Crystal River Unit 3  
Docket No. 50-302

Subject: Updated Design Information for the Auxiliary Feedwater Pump Addition

## AUXILIARY FEEDWATER PUMP ADDITION TO THE FEEDWATER SYSTEM

CRYSTAL RIVER 3  
ADD AFW PUMP FWP-7

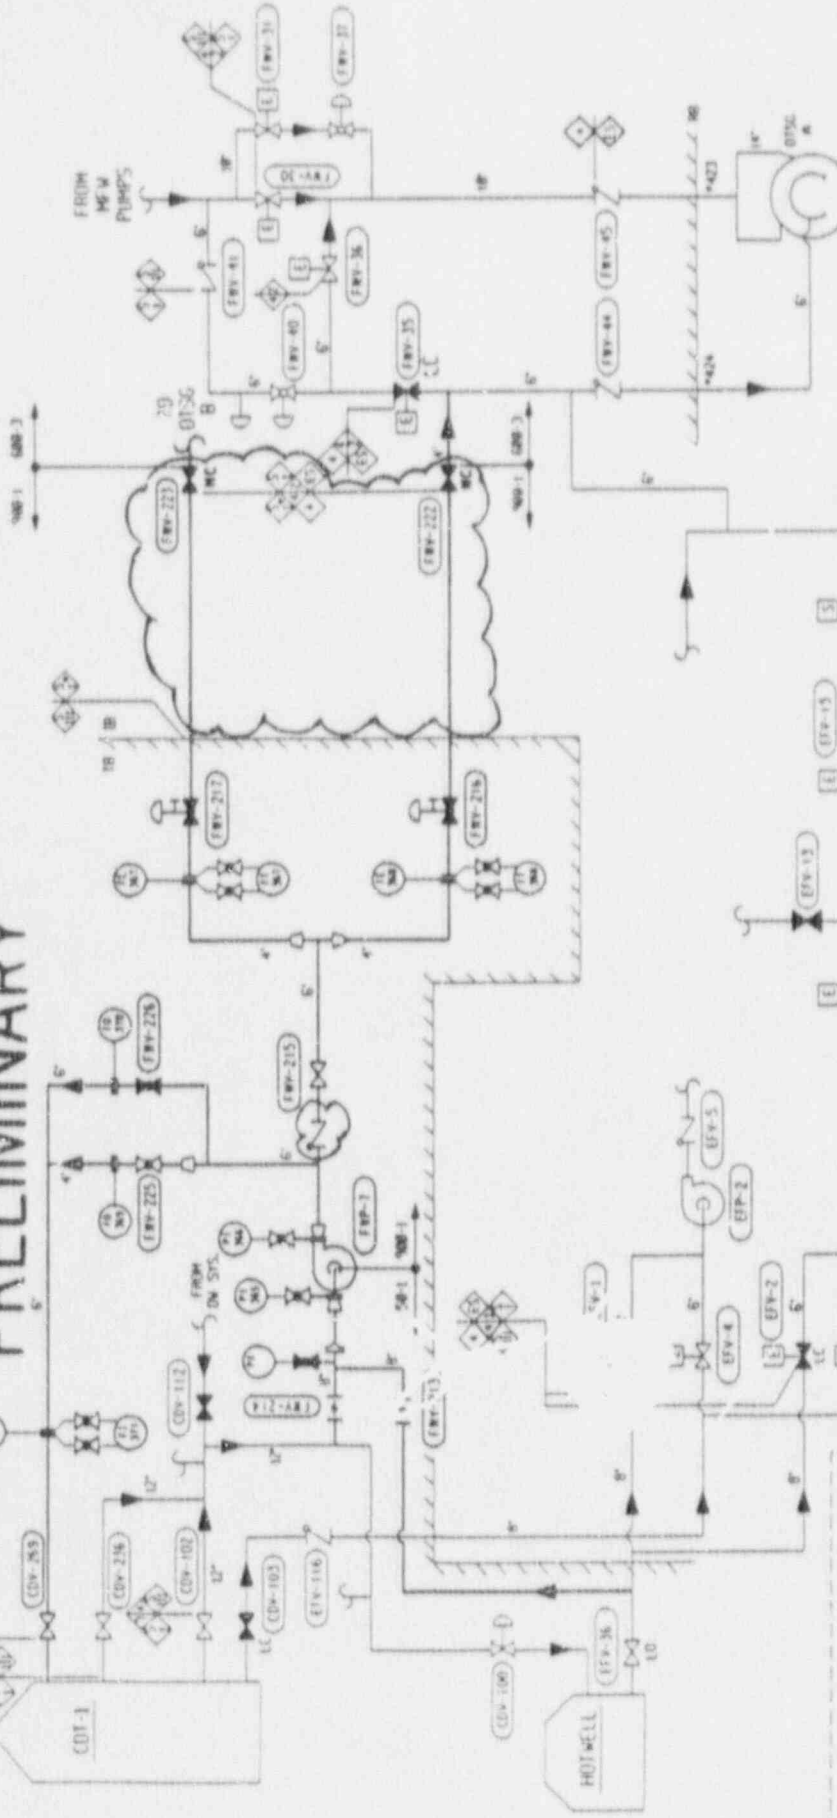
Since the conceptual design was submitted in the reference letter, FPC has evaluated the safety significance and cost benefit of the new AFW pump being totally initiated and controlled from the main control room. FPC has decided to proceed with a design in which the AFW pump is normally isolated from the Emergency Feedwater (EF) System with closed manually operated isolation valves. The installation of this AFW pump addition remains planned for Refuel 8, now scheduled for the Spring of 1992.

Changes to the Project Description (Attachment 1) are indicated by a black line in the right margin. Attachments 3 and 4 of the reference letter are not being updated with this submittal because they are conceptual piping layout drawings and this design revision is adequately shown in the schematic (Attachment 2). Attachment 5 is a bar chart with schedular information showing completion of the installation in Refuel 8. This schedule has not changed.

INDICATES CHANGES FOR RE-DESIGN TO MANUALLY ISOLATED AFW SOURCE

7. FWP-7 and AFW control valves FWV-216/217 will be designed for remote manual actuation from the Main Control Room. The AFW addition will be completely independent of EFIC, which controls the Emergency Feedwater System.

7. Flow will be independently regulated to each steam generator by new air-operated control valves, designated FWV-216 and FWV-217.
8. FWP-7 and the flow control valves will be remote manually operated from the main control room. The pump and valve controls will be located on the main control board near the controls for the Emergency Feedwater System and will consist of the following:

- a. Start the AFW pump (on recirculation) from the main control room.
  - b. Open manual isolation valves FWV-222 and FWV-223 located in the Intermediate Building.
